WINE EDUCATION CENTER  
NAPA VALLEY COLLEGE  
- PHASE 2  
(HOSPITALITY BUILDING)

ADDENDUM NUMBER 6

DATE  
**MARCH 27, 2025**

DSA APPLICATION NUMBER:  
**01-120890**

**4 WEST ELEVATION - PHASE 2 - GFRC PATTERN**  
 1/8" = 1'-0"

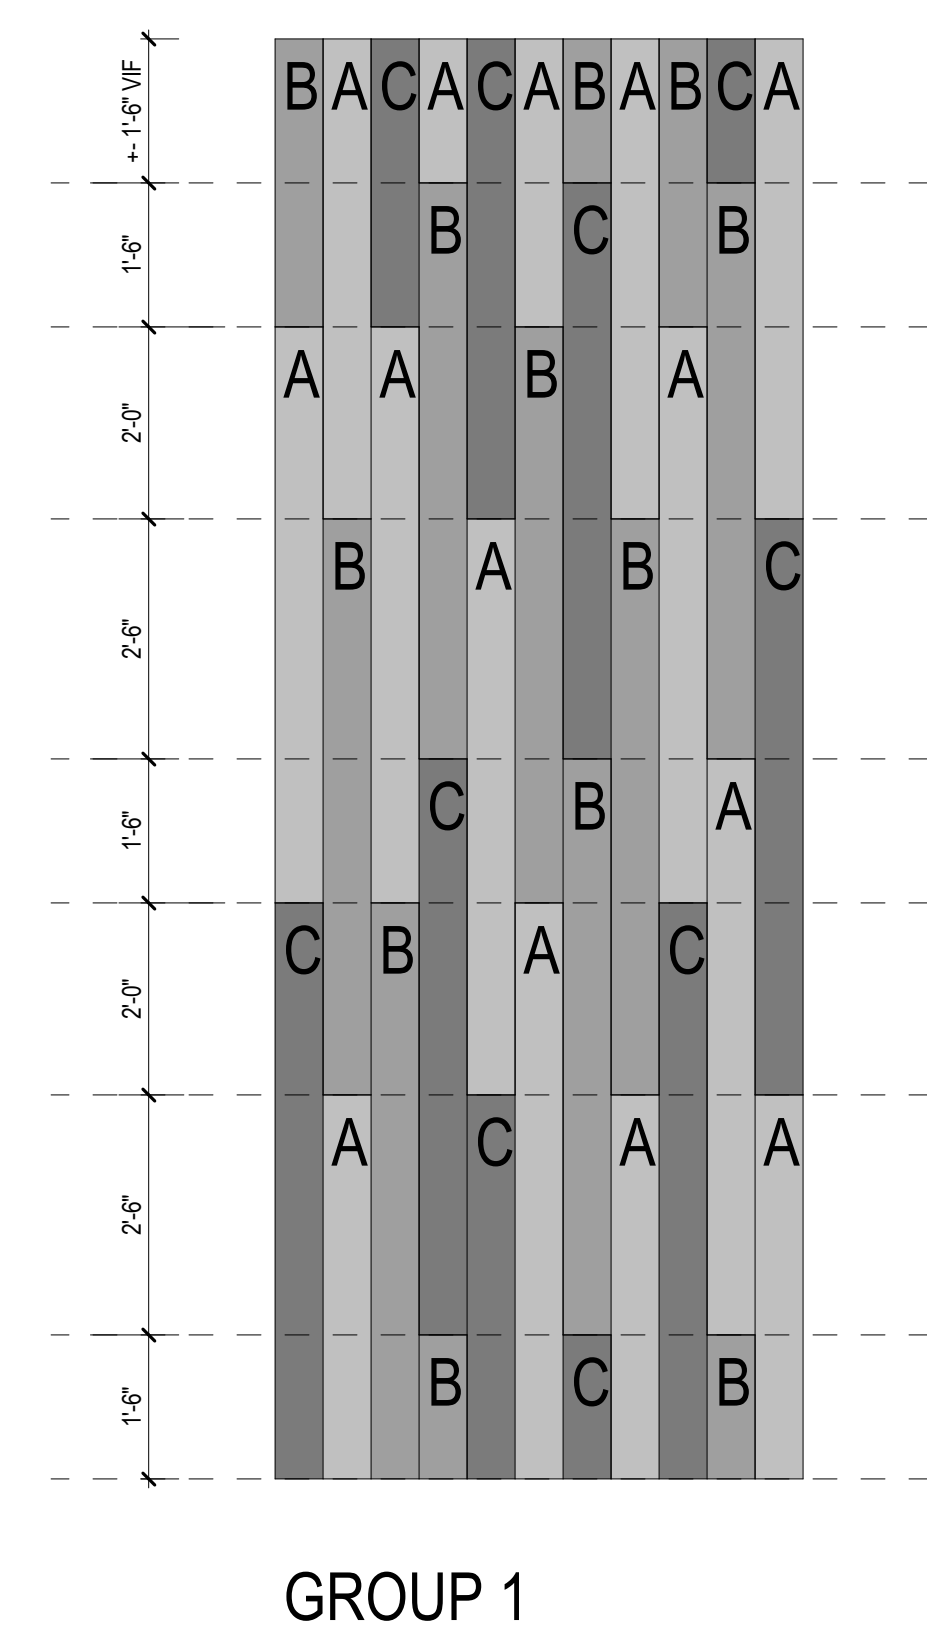
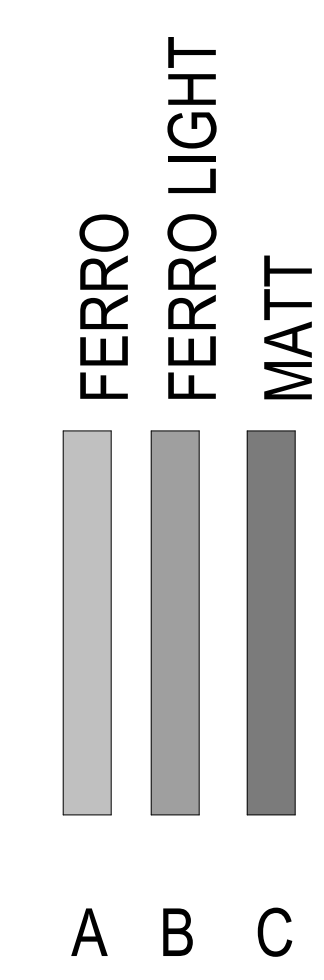
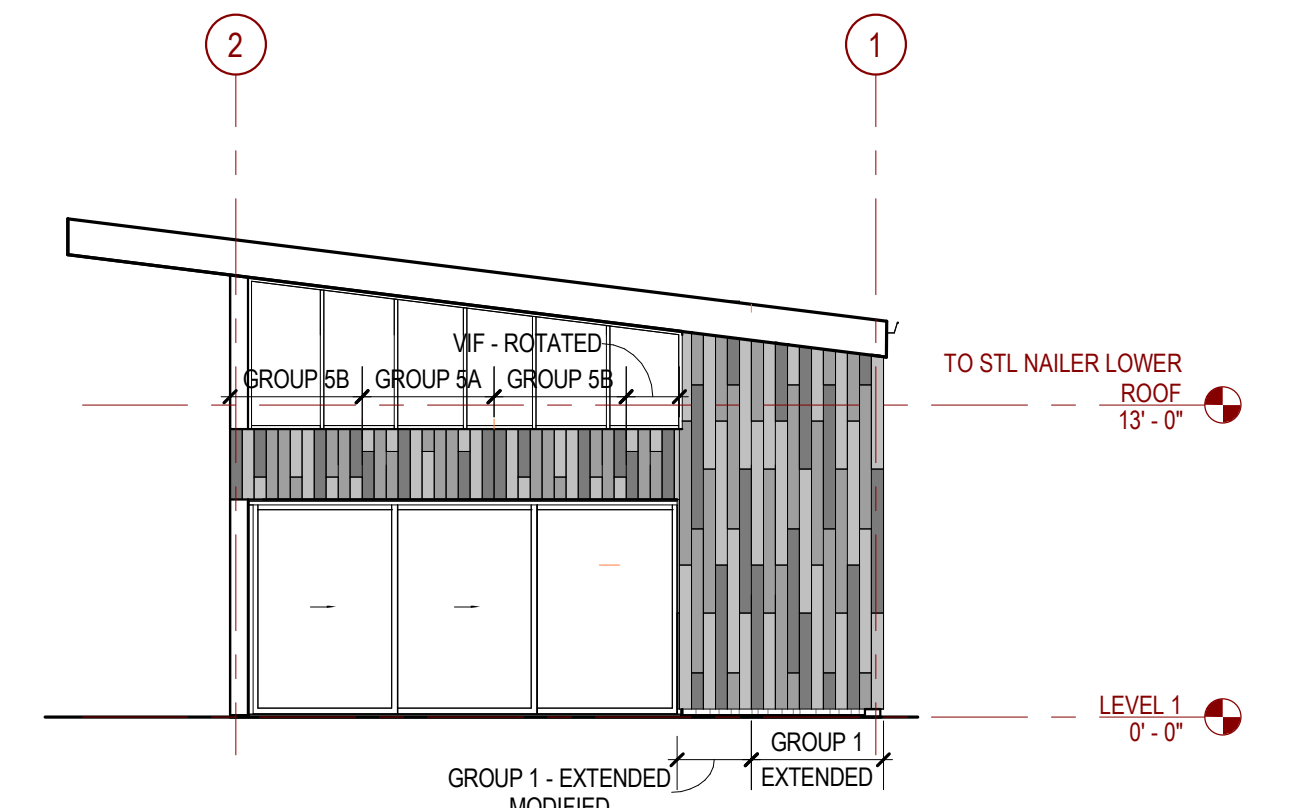
- d. West wall: Wall shall be fully sheathed due to double sided shear wall Type D.
- 1.3 **ADD** Drawing SKA-030 with clarifications to GFRC panel layout pattern.

- A. Refer to drawing SKA-030 for GFRC panel layout pattern for Phase 2. Refer to CCD 015, incorporated into the Phase 2 project in Addendum 4, for additional information for the exterior cladding system, attachments and waterproofing assembly. Refer to Addendum 5 for additional clarifications. Phase 2 GFRC products, attachments and assemblies shall match Phase 1 installation.

**PH 2 - FLOOR TILE  
 LAYOUT PATTERN**

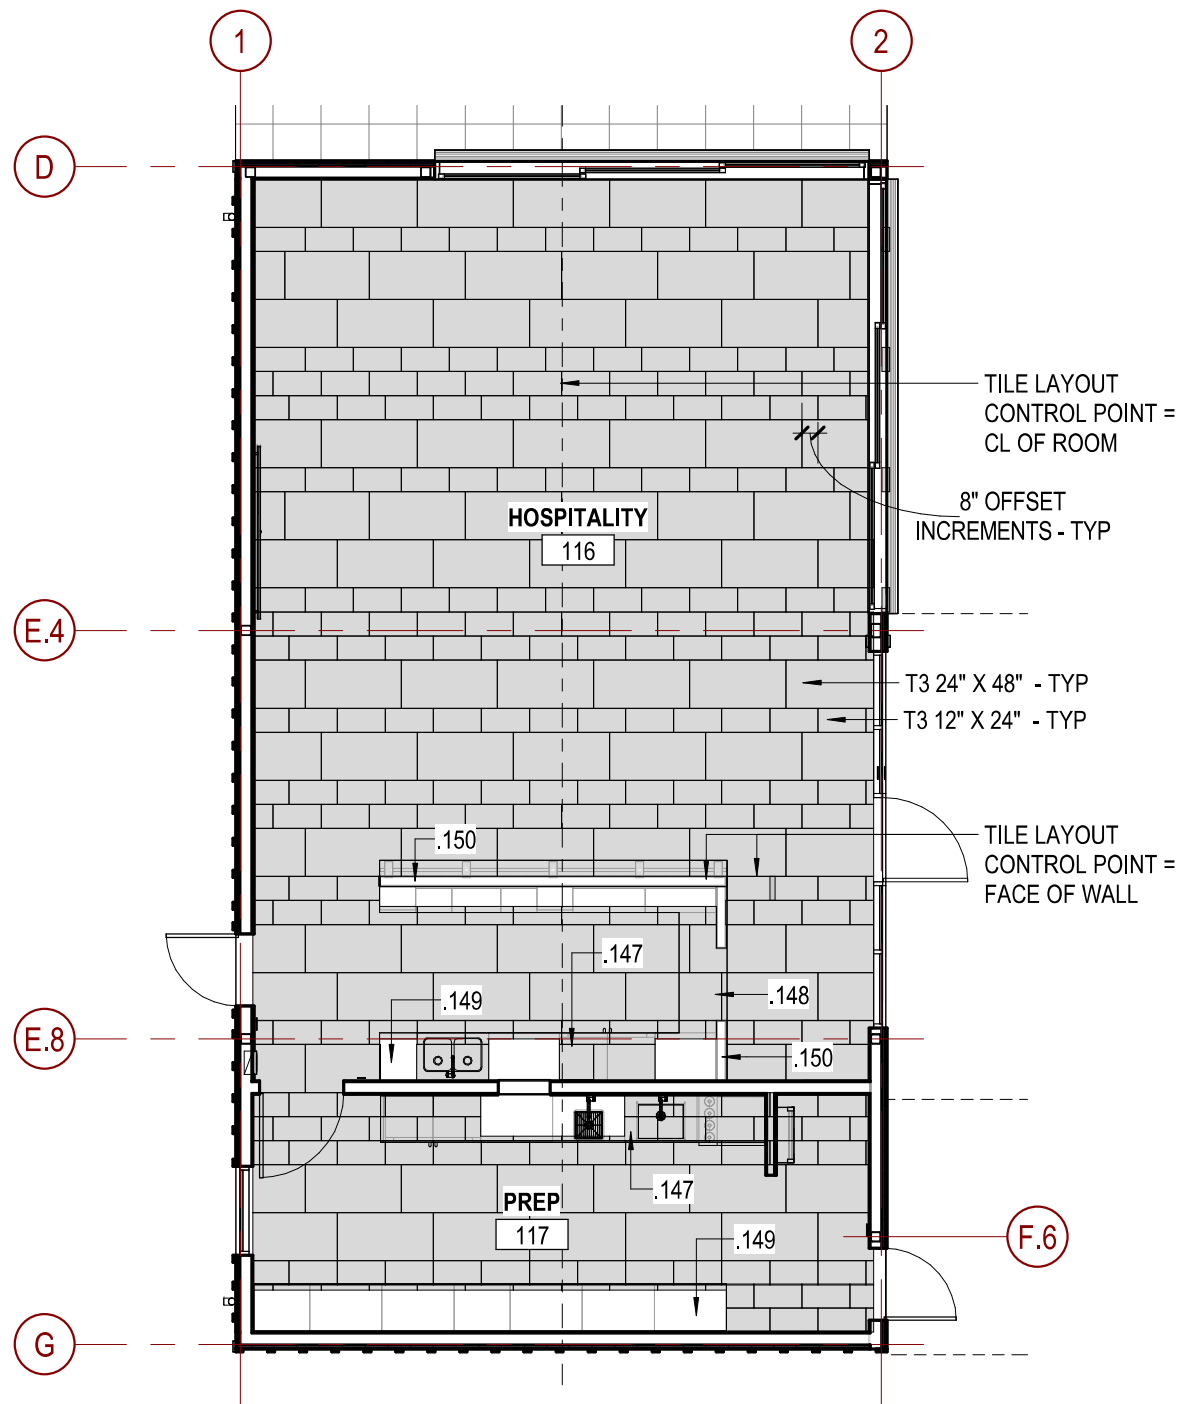
- 1.4 **ADD** Drawing SKA-031 with clarifications for random floor tile layout pattern.
- A. Refer to drawing SKA-31 for random floor tile layout pattern for Phase 2. Refer to Addendum 05 for change in tile product during Phase 1 construction. Adjust size of special tile trim pieces (Schluter) to fit thickness of the specified tile. Phase 2 tile products shall match tile products installed during Phase 1.

- .147 EXTEND FLOOR TILE INTO TO WALL IN OPEN BASE CABINET - TYP
- .148 EXTEND FLOOR TILE PATTERN THROUGH OPEN CABINET
- .149 BASE CABT - TYP
- .150 LOW WALL BELOW BAR COUNTER
